ADDENDUM NO. 1

Project: First United Methodist Church

Project No.: L09064.fum

Date: November 4, 2011

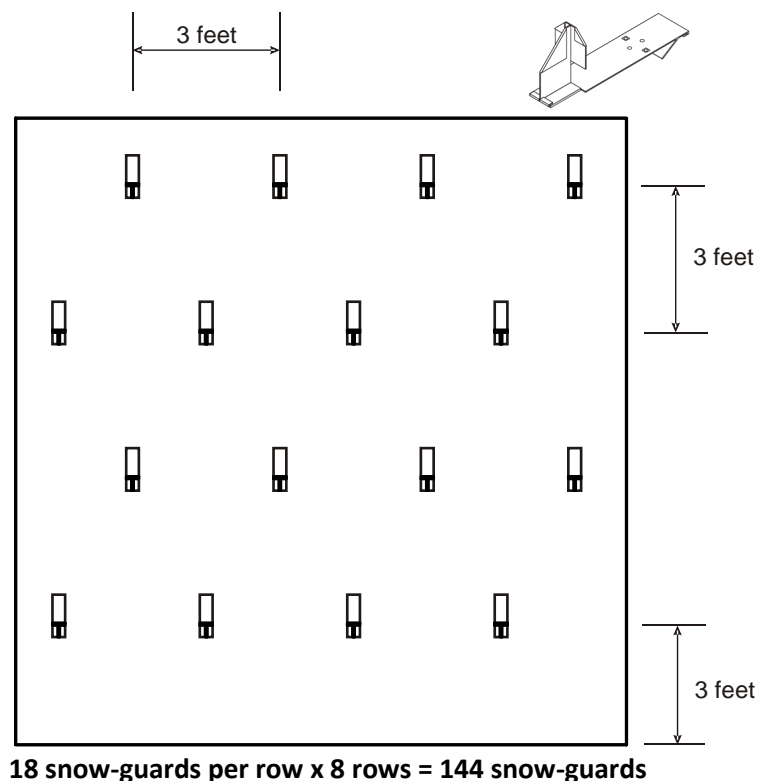
We recommend the following
 for a 6/12 slope, with a
 rafter length of 29 feet,
 asphalt-shingle roof.

Start 3 feet from eaves.

Horizontally 1st row 3 feet apart,
 Horizontally 2nd row 3 feet higher,
 Horizontally 3rd row 3 feet higher,
 Horizontally 4th row 3 feet higher.

Continue in increments of 3 feet to within 5 feet of the ridge at top.

Staggered course to course.

If the length of the building is 55 feet long, then 18 snow guards will be needed per row.

The rafter length being 29 feet, and 8 rows are suggested, then
 $18 \times 8 = 144 \div 2 = 72$ per side $\times 4$ sides = 288 snow guards.

Looking upward from the ground each vertical row would have 4 snow-guards.
 Looking upward from the ground each vertical row spacing would be 6 feet apart.

Snow has to be held in place to keep from starting to slide, not
 trying to stop it at the eaves once it gathers momentum.

1 EXISTING BUILDING FIRST FLOOR PLAN

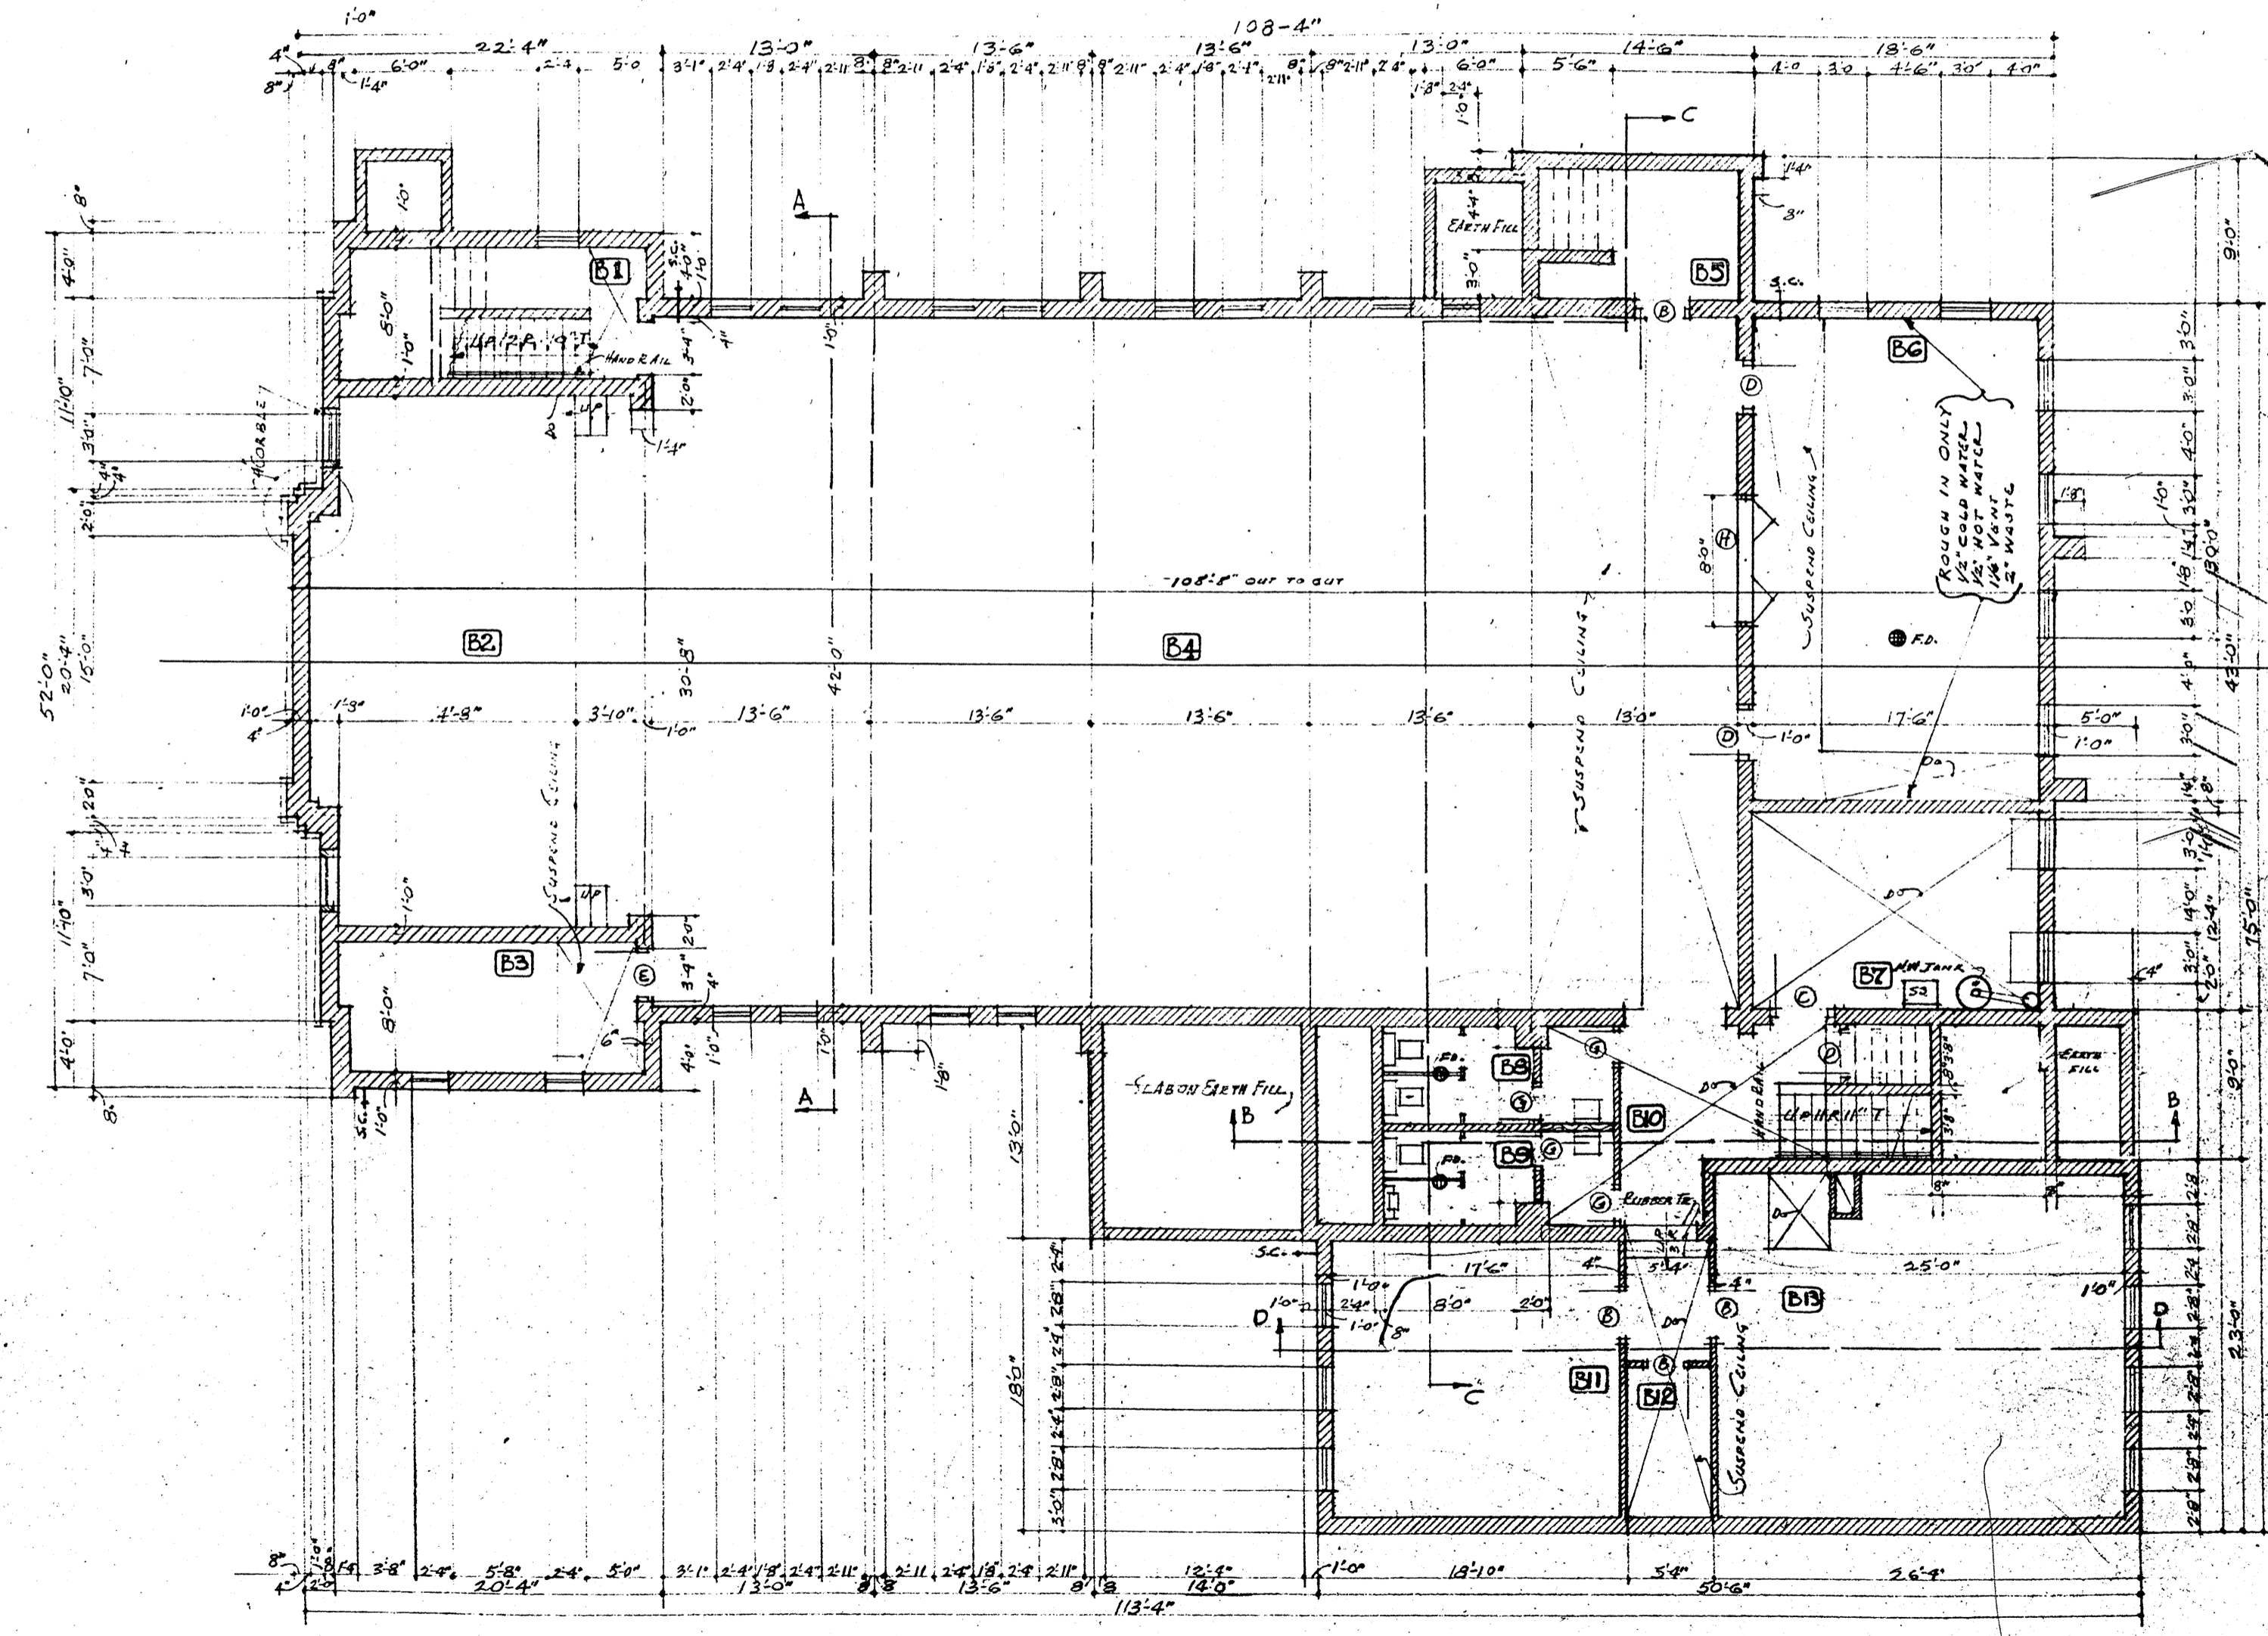
1. Sheet A4.1
 - A. Detail P1 – ATTIC MECH PENTHOUSE CEILING DETAIL
 - i. For walls in attic substitute wall type A1 with wall type F3.
2. See included dimensioned plan of existing church to determine Sprinkler layout.
3. See included original construction drawings for the existing church to determine Sprinkler layout.
